Project	IEEE 802.16 Broadband Wireless Access Working Group < http://ieee802.org/16 >	
Title	Efficient and Secure Security Framework in PKMv2	
Data Submitted	2005-03-09	
Source(s)	Seokheon Cho Sungcheol Chang Chulsik Yoon, ETRI 161, Gajeong-dong, Yuseong-Gu, Daejeon, 305-350, Korea	Voice: +82-42-860-5524 Fax: +82-42-861-1966 chosh@etri.re.kr
Re:	IEEE P802.16e/D6	
Abstract	The existing PKMv2 is somewhat unorganized and insecure security framework. This contribution provides a resolution for unorganized and insecure issues in the PKMv2.	
Purpose	Adoption of proposed changes into P802.16e/D6	
Notice	This document has been prepared to assist IEEE 802.16. It is offered as a basis for discussion and is not binding on the contributing individual(s) or organization(s). The material in this document is subject to change in form and content after further study. The contributor(s) reserve(s) the right to add, amend or withdraw material contained herein.

Efficient and Secure Security Framework in PKMv2

Seokheon Cho, Sungcheol Chang, and Chulsik Yoon

ETRI

2.1 IEEE P802.16e/D6 Status

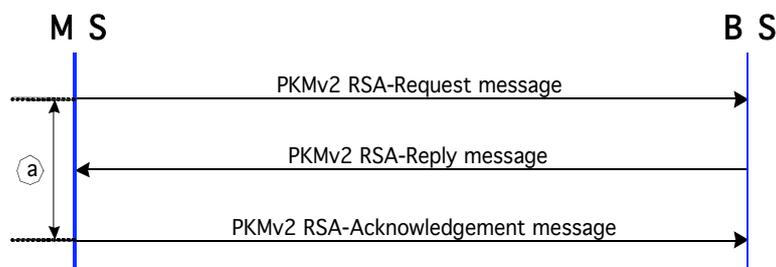
The AK is derived from the PAK or/and the PMK. The PAK and the PMK are obtained from the RSA-based Authorization procedure and the EAP-based Authorization procedure, respectively.

- For the RSA-based Authorization procedure:
 - The Authorization Request message and the Authorization Reply message in the RSA-based Authorization procedure are in the same rank as the EAP Transfer message in the EAP-based Authorization procedure. The Authorization Request/Reply messages contains Security-Capabilities, SAID, and SA-Descriptors, but the EAP Transfer message doesn't contain those parameters.

- The sequence number and lifetime included in the RSA-based Authorization procedure are not an AK sequence number and AK lifetime.
 - When the RSA-based Authorization procedure is selected, there is no message for informing the MS's authentication failure from BS to MS and the BS's authentication result (such as success or reject) from MS.

- For the EAP-based Authorization procedure:
 - The Key Sequence Number used in the Protected EAP-Transfer message is not an AK Sequence Number.
 - The BS doesn't know the completion time of the EAP-based Authorization procedure in case that EAP protocol doesn't yield AAA-key and whether an MS receives the last EAP Transfer message (such as "EAP Success" used in EAP-TLS) or not. Both the BS and the MS cannot simultaneously share the AK derived from PMK, when an MS doesn't receive the last EAP Transfer message.

- AK generation process needs more secure mechanism.

- b) For the EAP-based Authorization procedure:

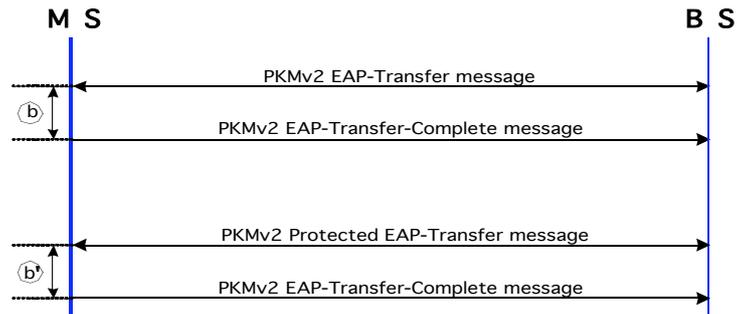
- The messages used in the EAP-based Authorization procedure are as follows
- The Key Sequence Number used in the PKMv2 Protected EAP-Transfer message is not an AK sequence number but PAK sequence number.
- In order that BS knows the completeness time of EAP-based Authorization procedure in case that EAP protocol doesn't yield AAA-key and whether a MS receives the last EAP Transfer message (such as "EAP Success" used in EAP-TLS) or not, an MS shall send the PKMv2 EAP-Transfer-Complete message to report EAP-based Authorization completeness. Therefore, both MS and BS can synchronize the AK.

- i. PKMv2 EAP-Transfer message: EAP Payload
- ii. PKMv2 Protected EAP-Transfer message: Key Sequence Number (PAK), EAP Payload, OMAC Digest (from EIK)
- iii. PKMv2 EAP-Transfer-Complete message:

c) For MS's Authorization Key Generation procedure:

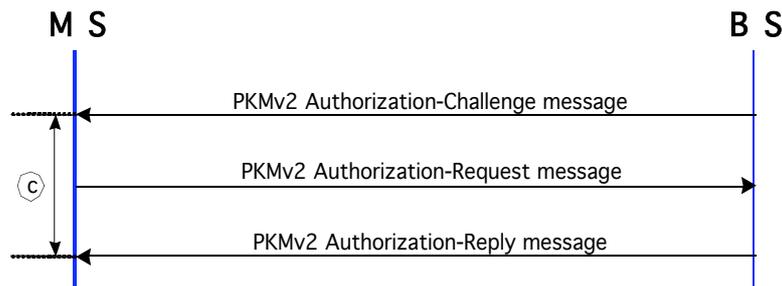
- To assure more secure AK, seeds (such as MS_Nonce and BS_Nonce) should be used to derive AK.
- To protect from replay-attack, the messages needed in MS's AK Generation procedure should contains random number (such as MS_Nonce and BS_Nonce) and message authentication function (such as OMAC Digest).
- The messages with important parameters, e.g. Security-Capabilities, SAID, and SA-Descriptors, should be authenticated.
- This procedure supports secure 3 way handshake.

- i. PKMv2 Authorization-Challenge message: BS_Nonce
- ii. PKMv2 Authorization-Request message: Key Sequence Number (PAK), MS_Nonce, BS_Nonce, Security_Capabilities, SAID, OMAC Digest (from AK)
- iii. PKMv2 Authorization-Reply message: Key Sequence Number (AK), Key Lifetime (AK), BS_Nonce, (one or more) SA-Descriptor(s), OMAC Digest (from AK)
- iv. PKMv2 Authorization-Reject message: Error-Code, Display-String, BS_Nonce, OMAC Digest (from AK)

Figure -AK with the only RSA-based authorization process

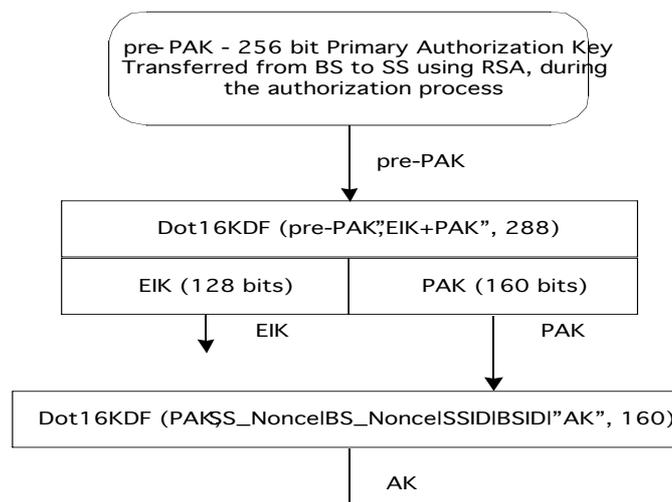
- a) To derive AK, 3 way handshake procedure is newly provided as follows.
 - The MS_Nonce and the BS_Nonce generated from the MS and the BS respectively. These MS_Nonce and BS_Nonce with PAK or/and PMK shall be used to generate AK.

- The new key hierarchy is as follows.

5.1 IEEE P802.16e/D6 Status

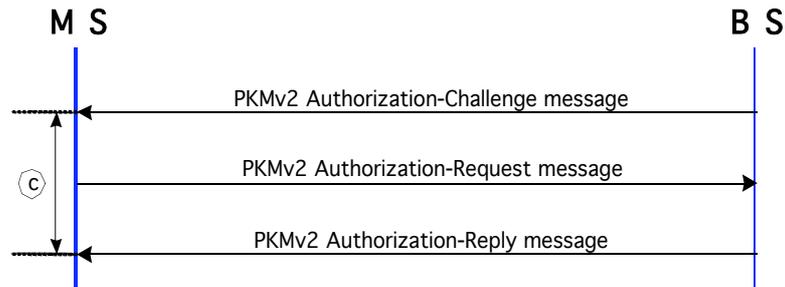
There are messages related to 3 way handshake SA-TEK exchange, e.g. SA-Challenge, SA-TEK-Request, and SA-TEK-Response. These messages are used during initial network entry, reauthorization, HO.

- The Security_Capabilities, SAID, and SA-Descriptors attributes are included in SA-TEK exchange. However, negotiation of Security_Capabilities and SA-Descriptor should be done before the MS generates and distributes the TEK. It is reasonable that those attributes should be negotiated during the AK generation procedure.

- The SA-Descriptors included in SA-TEK exchange identifies the Primary and Static SAs the requesting MS is authorized to access and their particular properties. In the case of the multicast service, it is so dangerous to distribute the information of all Static SAs (including static SAID and static TEK-parameters) without DSx-exchange procedure (= without user's use intention for the multicast service). In order to use this SA-TEK exchange procedure, all DSx-exchanges for Static SAs should be performed.

- It is already defined that the TEK doesn't need to be updated during reauthorization in the IEEE P802.16d/D5. Thus, the TEK doesn't need to be refreshed during HO. The TEK-parameters transfer and share among BSs should be guaranteed. If not, no information shall be shared among BSs and even HO-optimization is impossible.

- a) It is appropriate that Security_Capabilities and SA-Descriptors should be transferred not during the TEK exchange procedure but during the MS's AK generation procedure. The following MS's Authorization Key Generation procedure shall support the above solution and transfer those attributes securely.

- v. PKMv2 Authorization-Challenge message: BS_Nonce
 - vi. PKMv2 Authorization-Request message: Key Sequence Number (PAK), MS_Nonce, BS_Nonce, Security_Capabilities, SAID, OMAC Digest (from AK)
 - vii. PKMv2 Authorization-Reply message: Key Sequence Number (AK), Key Lifetime (AK), BS_Nonce, (one or more) SA-Descriptor(s), OMAC Digest (from AK)
 - viii. PKMv2 Authorization-Reject message: Error-Code, Display-String, BS_Nonce, OMAC Digest (from AK)
- b) The DSx-exchange procedure (user's intention) should precede the TEK exchange procedure, especially the multicast service to use Static SA. It is appropriate to use the PKMv2 Key-Request and the PKMv2 Key-Reply message after performing DSx-exchange procedure.

Figure xxx-MS Authorization Procedure in PKMv2

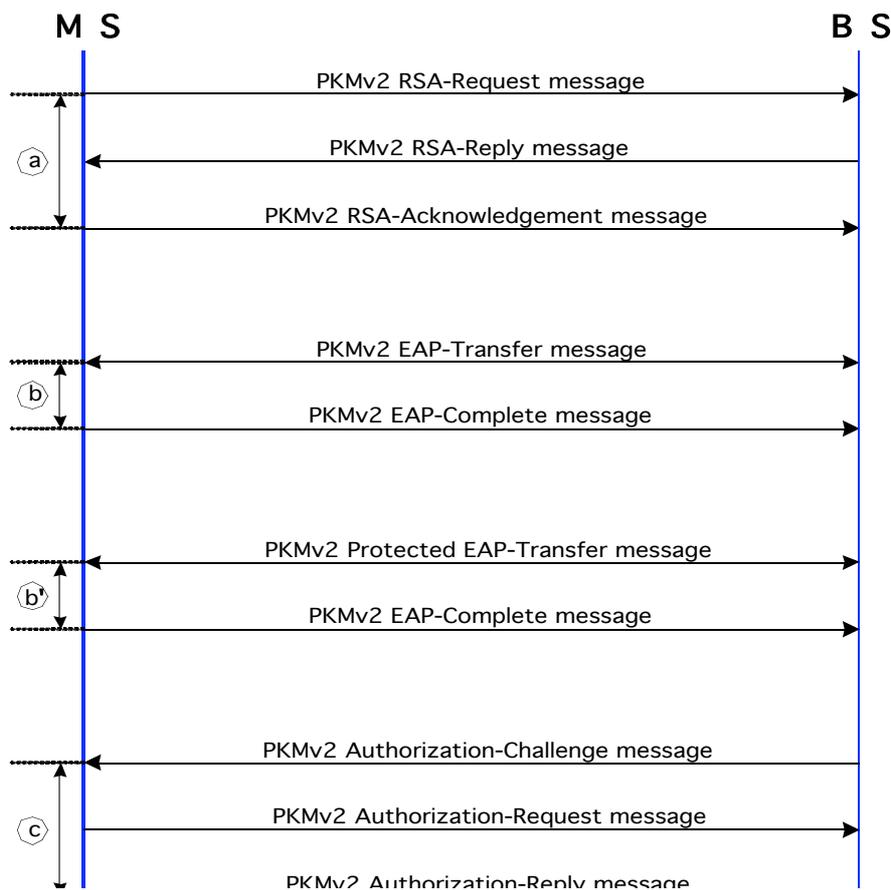
MS authorization procedure in PKMv2 constitutes three authorization exchange ways as shown in Fig xxx. Three authorization exchange ways are the RSA-based authorization process (), the EAP-based authorization process (or _), and the MS's Authorization Key Generation process ().

There are PKMv2 RSA-Request, PKMv2 RSA-Reply, PKMv2 RSA-Reject, and PKMv2 RSA-Acknowledgement messages needed in the RSA-based authorization process (). Both MS and BS shall share the same PAK derived from the pre-PAK.

There are two kinds of procedures in the EAP-based authorization process; the EAP Transfer procedure () to transfer only EAP payload and the Protected EAP Transfer procedure () to assure secure EAP payload transfer. Both MS and BS can share the same PMK derived from the AAA-key. Depending on the EAP protocol, however, the EAP method used can not yield an AAA-key and both of them shall not share the PMK.

There are PKMv2 Authorization-Challenge, PKMv2 Authorization-Request, and PKMv2 Authorization-Reply, and PKMv2 Authorization-Reject messages needed in the MS's Authorization Key Generation process (). Both MS and BS shall share the same AK derived from the PAK or/and the PMK, obtained in the RSA-based authorization process and the EAP-based authorization process, respectively.

Figure 131-AK with the only RSA-based only authorization process

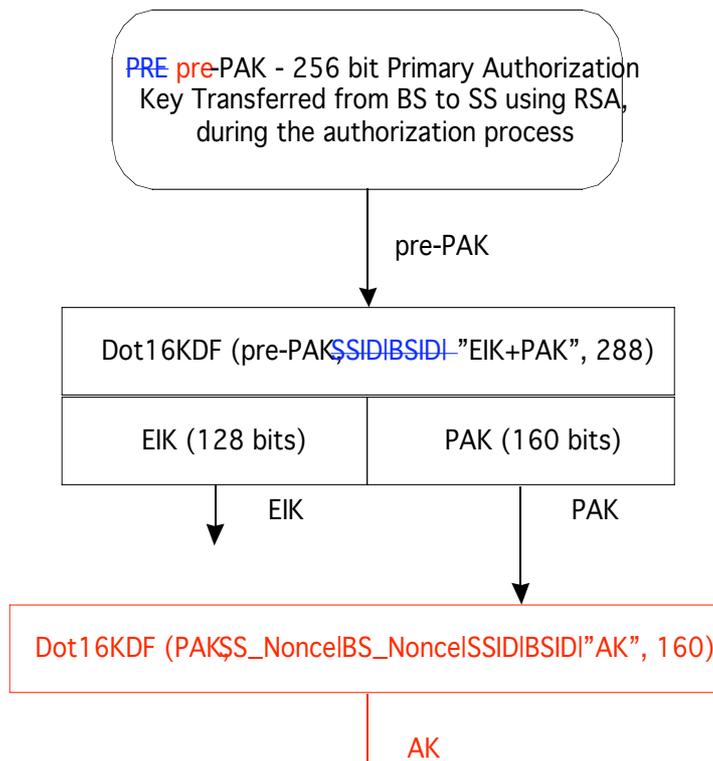
Figure 131 outlines the process to calculate the AK when the RSA-based authorization process has taken place, but where the EAP-based authentication process hasn't taken place, or the EAP method used has not yielded an AAA-key:

Figure 132-AK with RSA and EAP authorization process

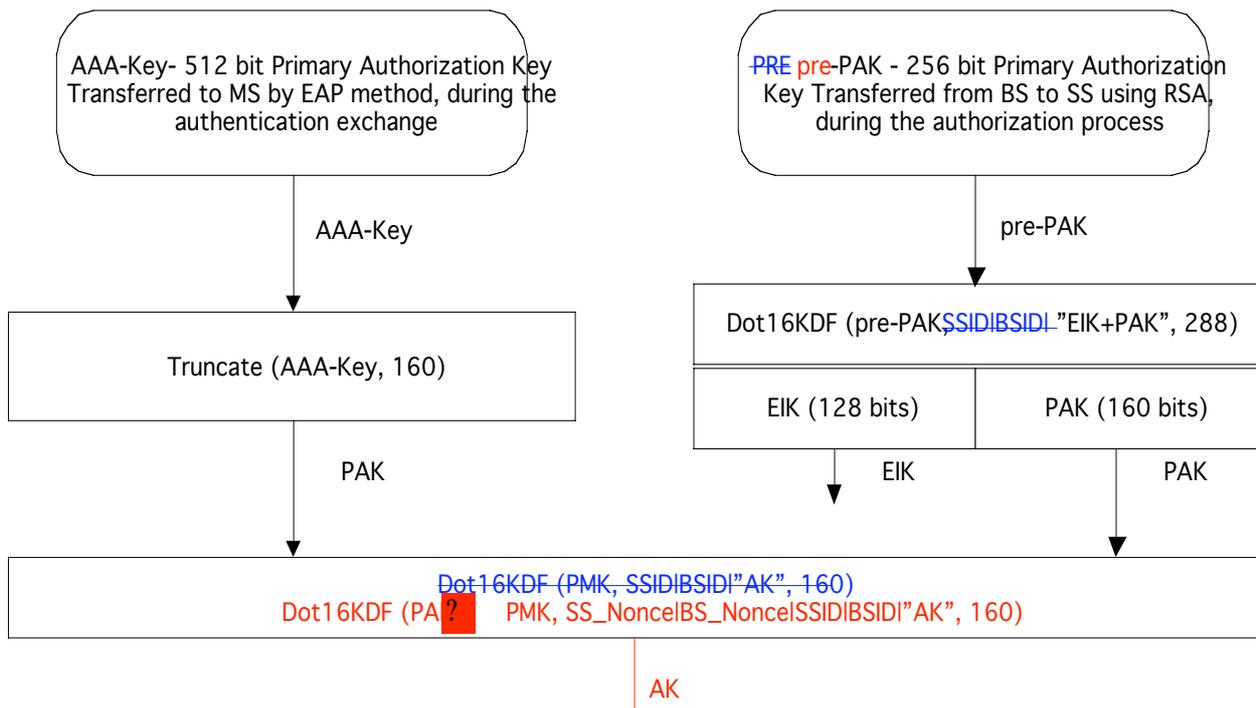
Figure 132 outlines the process to calculate the AK when both the RSA-based authorization exchange has taken place, yielding a PAK and the EAP based authentication exchange has taken place, yielding an AAA-key:

Figure 133-AK with the only EAP-based authentication authorization process

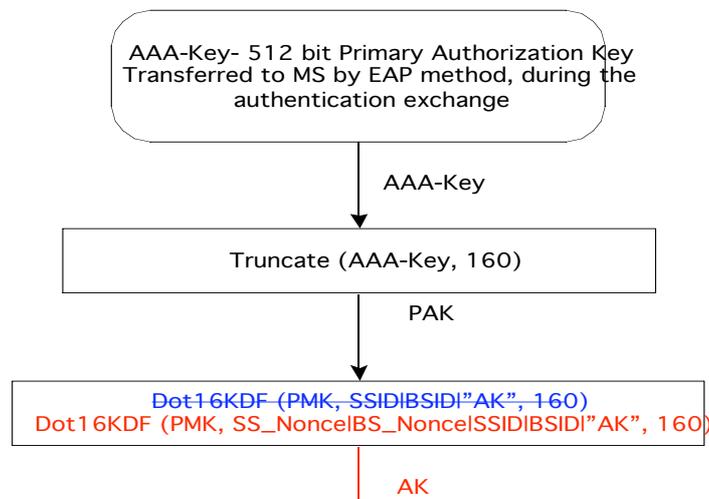
Figure 133 outlines the process to calculate the AK when only the EAP based authentication exchange has taken place, yielding an AAA-key:
